**ALBERTA TRANSPORTATION
SPRINGBANK OFF-STREAM RESERVOIR
PROJECT
Response to NRCB and AEP
Supplemental Information Request 2,
dated November 18, 2019**

Prepared for:
Alberta Transportation

Prepared by:
Stantec Consulting Ltd.

April 2020

Sources: Base Data - Government of Alberta, Government of Canada. Thematic Data - Stantec Ltd.

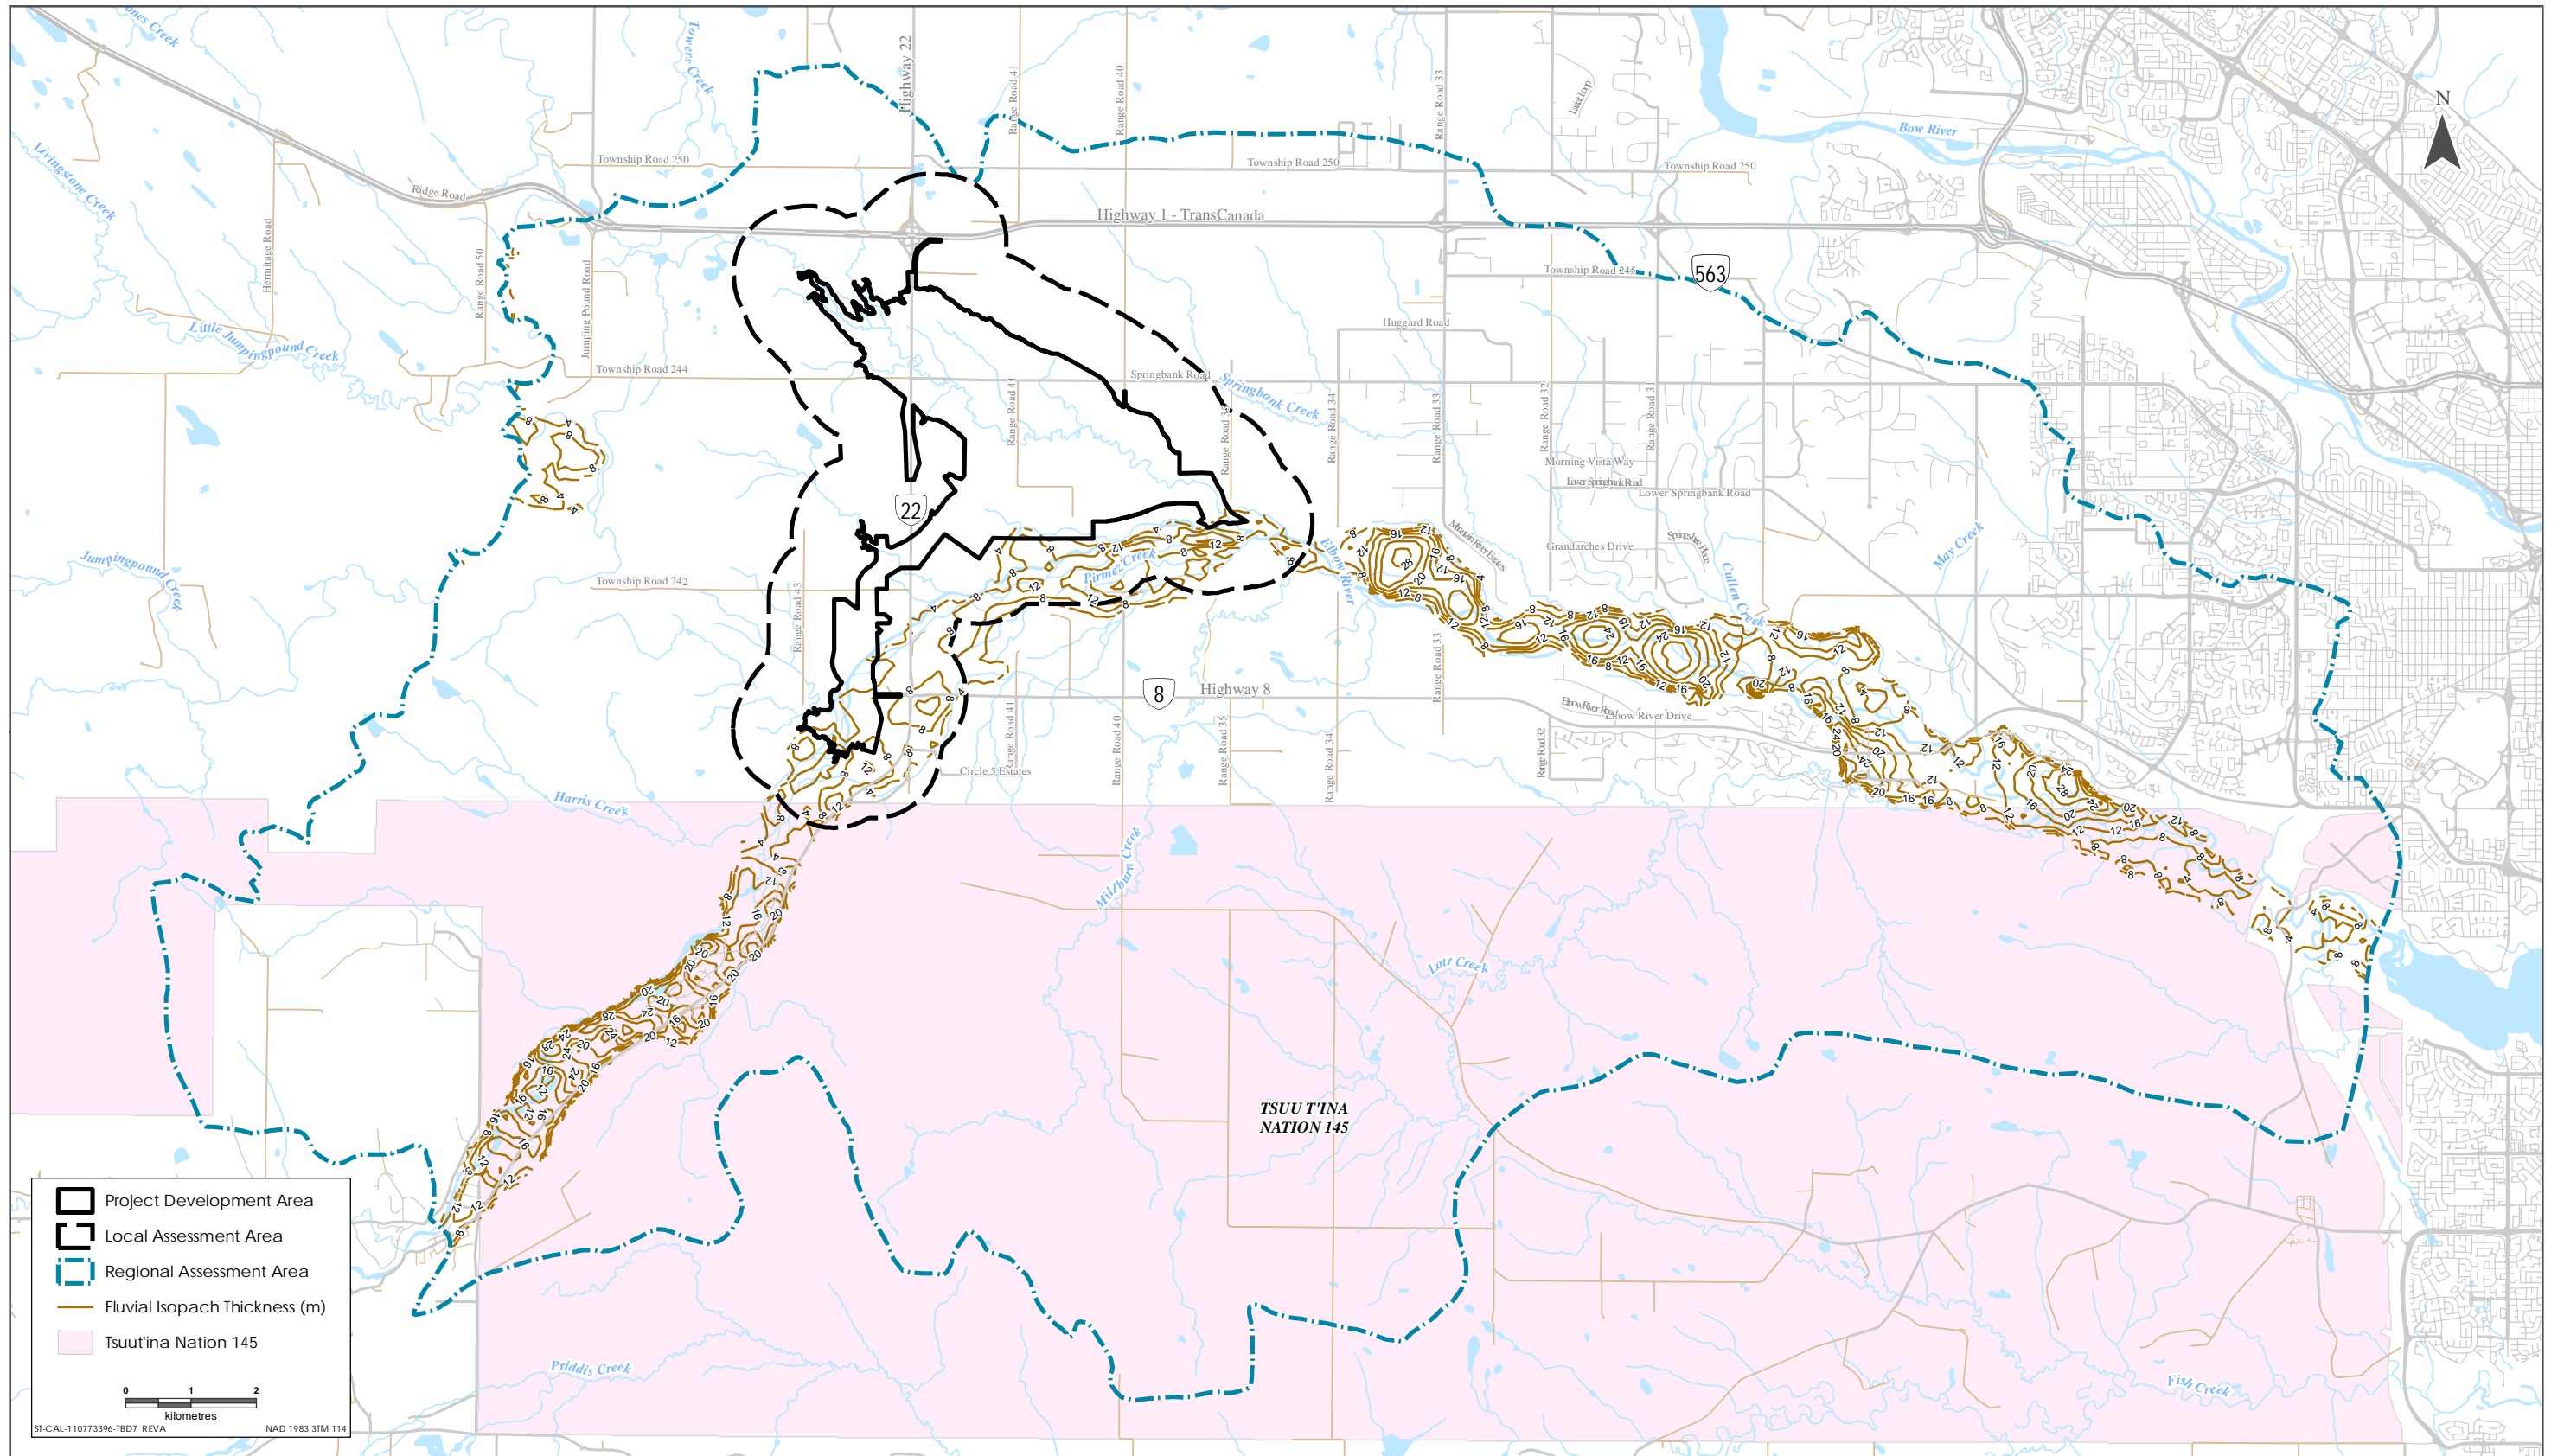
Figures 3-8, 3-10 and 3-12 in Appendix IR42-1 show isopach maps for glacial till, glaciolacustrine, and recent fluvial deposits. Contour labels are not shown for all areas in the expanded RAA and it is not obvious what they are.

- a. Provide the missing labels for the isopach contours in the expanded RAA.**

- a. The contour labels in Alberta Transportation's response to Round 1 Natural Resources Conservation Board (NRCB) information request (IR)42-1, Appendix IR42-1, Figures 3-8, 3-10 and 3-12 have been revised in the following figures: Figure 5-1, Figure 5-2, and Figure 5-3.

Figure 7-1. MW16-15-34 Groundwater Elevation

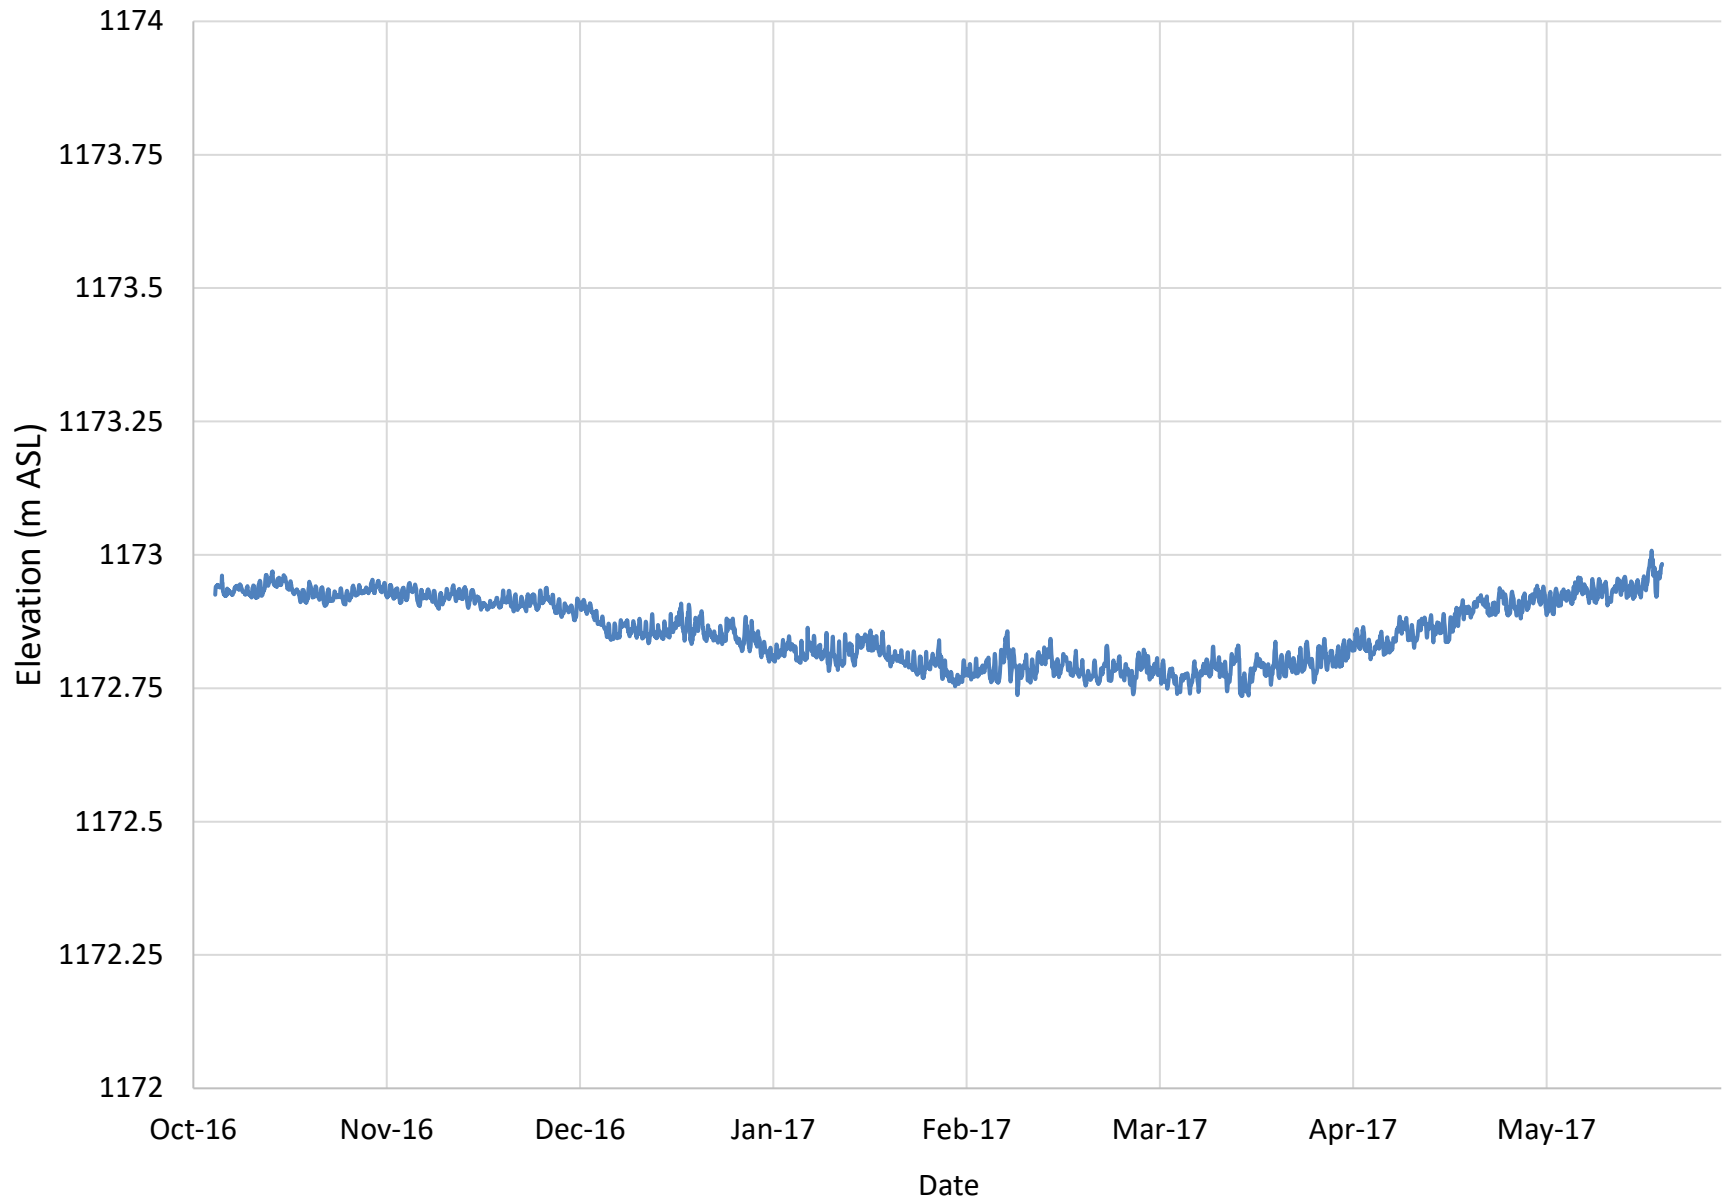
The hydrograph for monitoring well MW16-8-19 is repeated several times in Figure 3-26. Table 2-1 shows that pressure transducers were installed in MW16-15-34, MW16-7-5 and MW16-18-6 and these are not shown in the referenced figures. Figure 3-24 includes a hydrograph for monitoring well MW16-17-5, however Table 2-1 shows that no pressure transducer was installed.

- a. Provide the hydrographs of monitoring wells MW16-15-34, MW16-7-5 and MW16-18-6. In addition, clarify whether a pressure transducer was installed at MW16-17-5. If no transducer was installed at MW16-17-5 then correct and update the document.

- a. There were errors that led to a discrepancy between TDR Update (see Alberta Transportation's response to Round 1 AEP IR42, Appendix IR42-1), Figure 3-24, Figure 3-25, and Figure 3-26 compared to page 3.50, page 3.52 and Table 2-1, page 2.7.

The hydrograph for MW16-8-19 appears in Figure 3-25 and Figure 3-26 multiple times as an error and, as a result, the hydrographs for MW16-15-34 and MW16-18-10 were not included. These two hydrographs are provided in Figure 7-1 and Figure 7-2.

Figure 8-1 Estimated Change in Hydraulic Head at the Edge of the Reservoir using an Analytical Solution (Aquifer $K = 1.4E-06$ m/s)

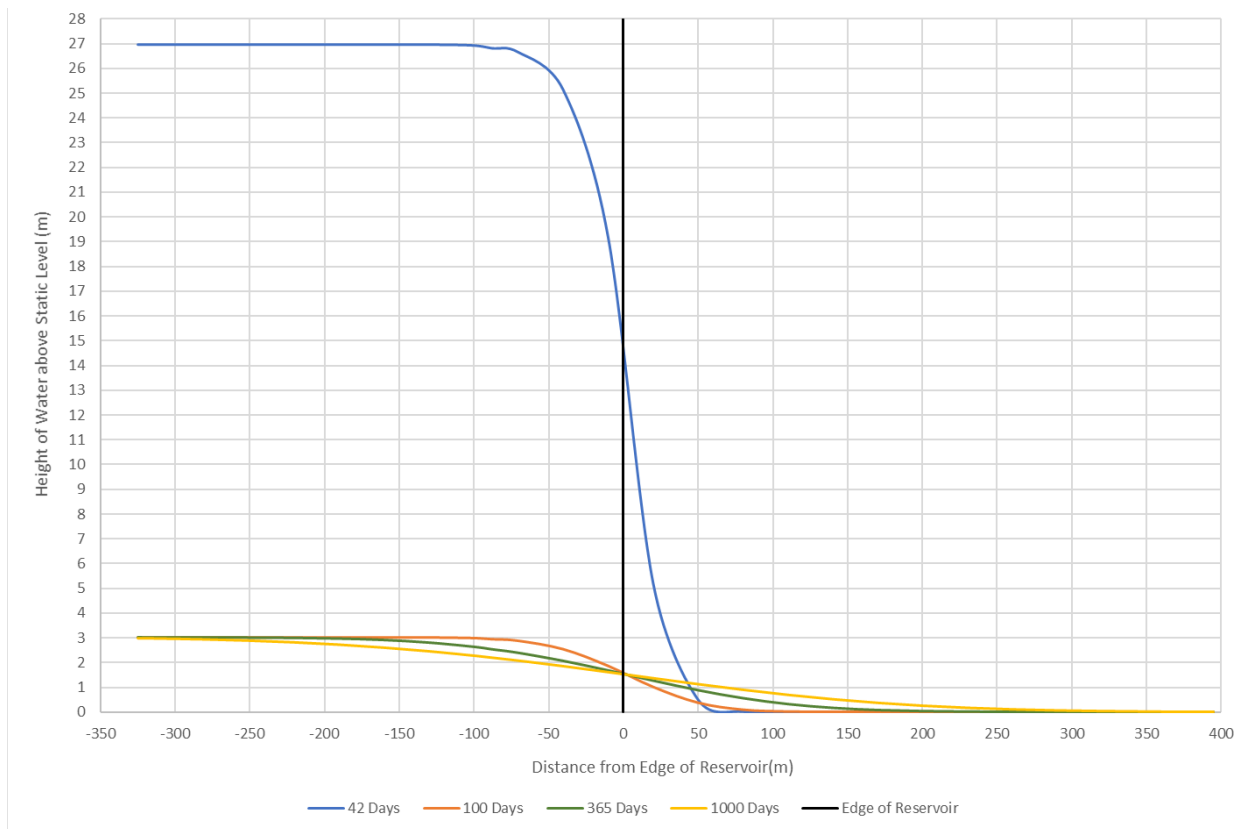
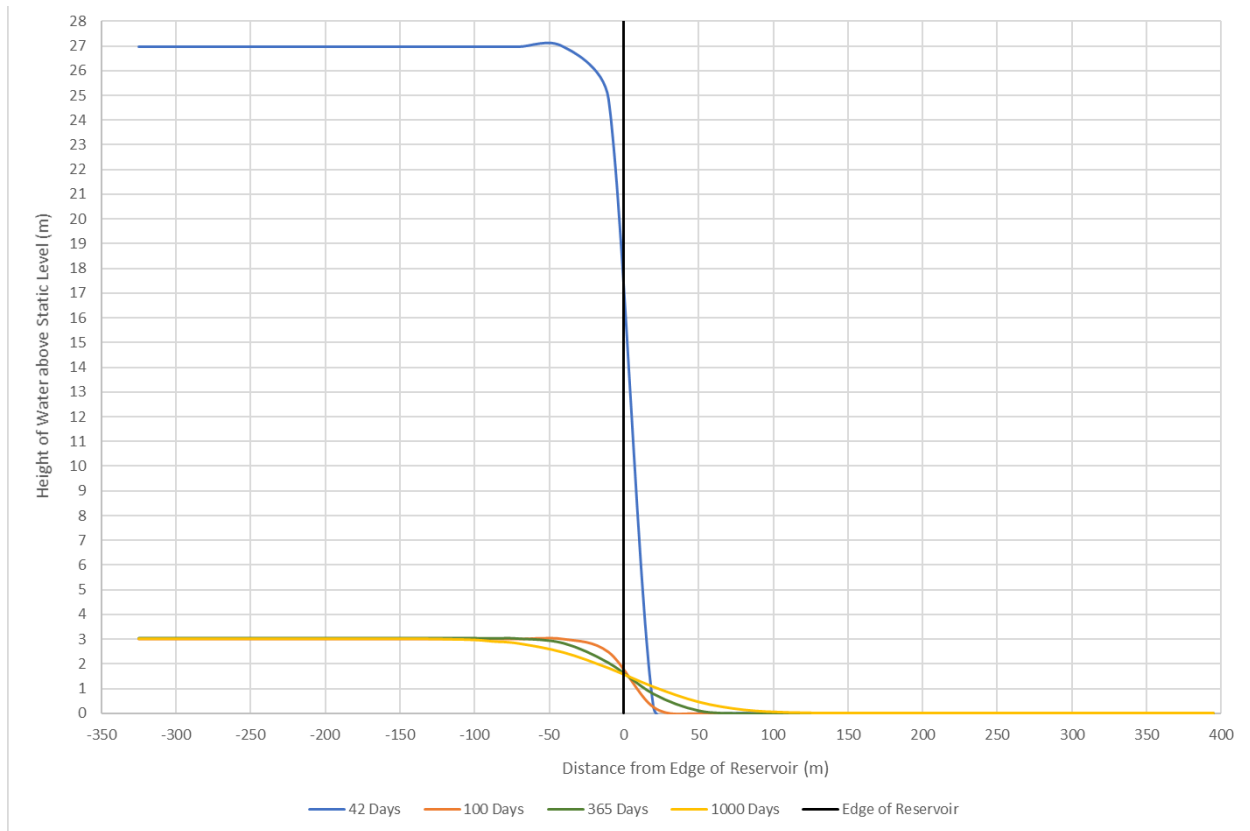
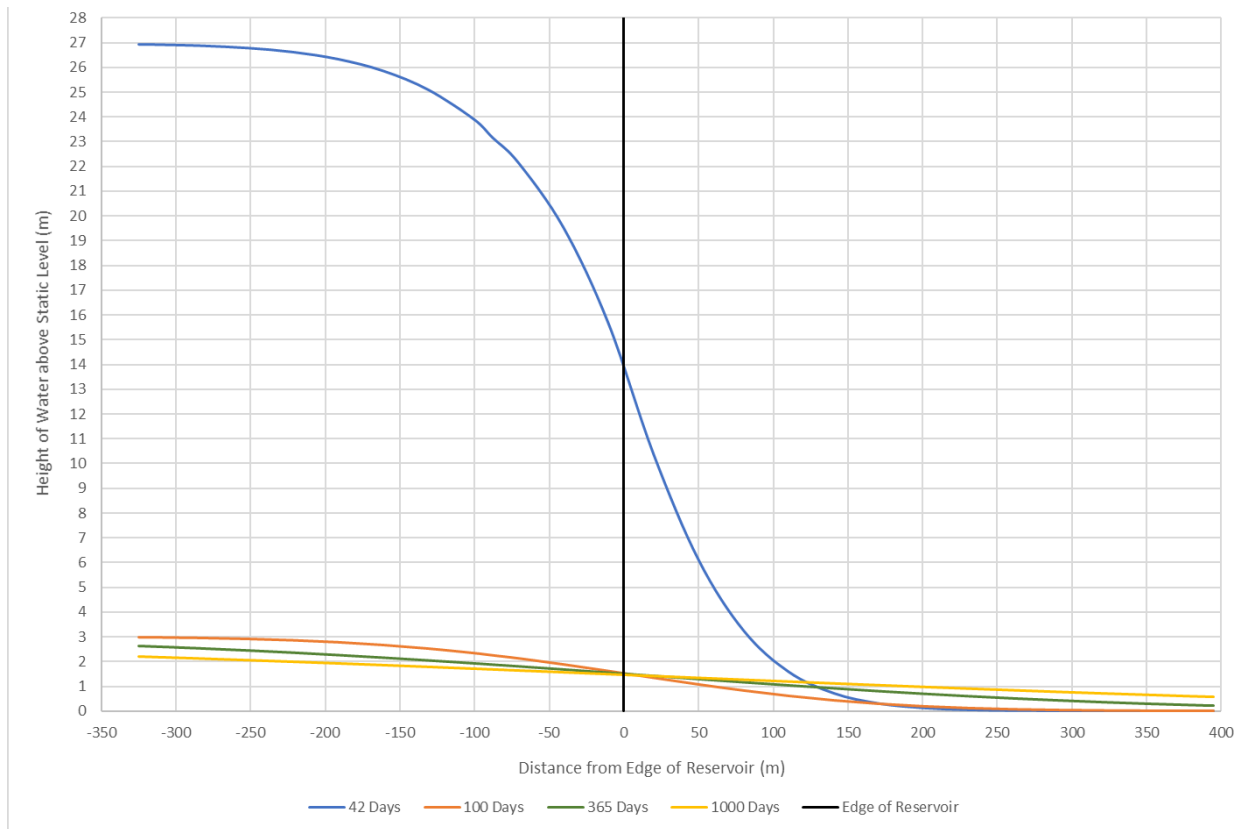
Appendix IR42-1, Section 5 summarizes the predicted effects of the project on water levels. Appendix IR42-1, Figure 5-13 displays simulated head increase up to 24m in the reservoir, yet after timestep 650 there is less than 0.5m of head increase adjacent to the reservoir.

- a. Confirm the elapsed time associated with timestep 650.
- b. Discuss why is there no propagation of drawdown away from the reservoir in Figure 5- 13. Comment on whether the lack of drawdown has been validated by approximating the problem with an analytical solution.
- c. Discuss whether the settings that control the behavior of the phreatic surface are adversely affecting the simulated response to flooding.

Figure 8-1 through Figure 8-3 present the results of the analytical solution using the varied hydraulic conductivity values for the aquifer unit. Calculated hydraulic head profiles are presented for 42 days of retention in the reservoir, full level, and after 100, 365, and 1,000 days following release of retained water from the reservoir.

Figure 8-1 presents an idealized cross-section through the edge of the reservoir area showing the change in hydraulic head over space and time using the calibrated hydraulic conductivity (derived from the numerical groundwater flow model) of the upper bedrock aquifer ($1.4E-6\text{m/s}$).

Figure 8-1 shows that the analytical solution predicts that increases in groundwater levels greater than 0.5 m are limited to distances of approximately 150 m beyond the edge of the reservoir. The analytical solution, therefore, supports the limited propagation of effects similarly predicted in the numerical modelling results: in both the numerical model and the analytical solution, the effects of water level increases are limited to within the local area.

The sensitivity of the analytical solution to changes in hydraulic conductivity is shown in Figure 8-2 and Figure 8-3. Figure 8-2 presents the results of the analytical solution using an order of magnitude lower hydraulic conductivity value of $1.4 \text{ E-}7 \text{ m/s}$. The lower conductivity results in propagation of groundwater increases greater than 0.5 m to approximately 50 m from the edge of the reservoir.

In Figure 8-3, The propagation of effects predicted using the higher conductivity of $1.4 \text{ E-}5 \text{ m/s}$ shows increases of up to 0.5 m extending approximately 425 m from the edge of the reservoir.
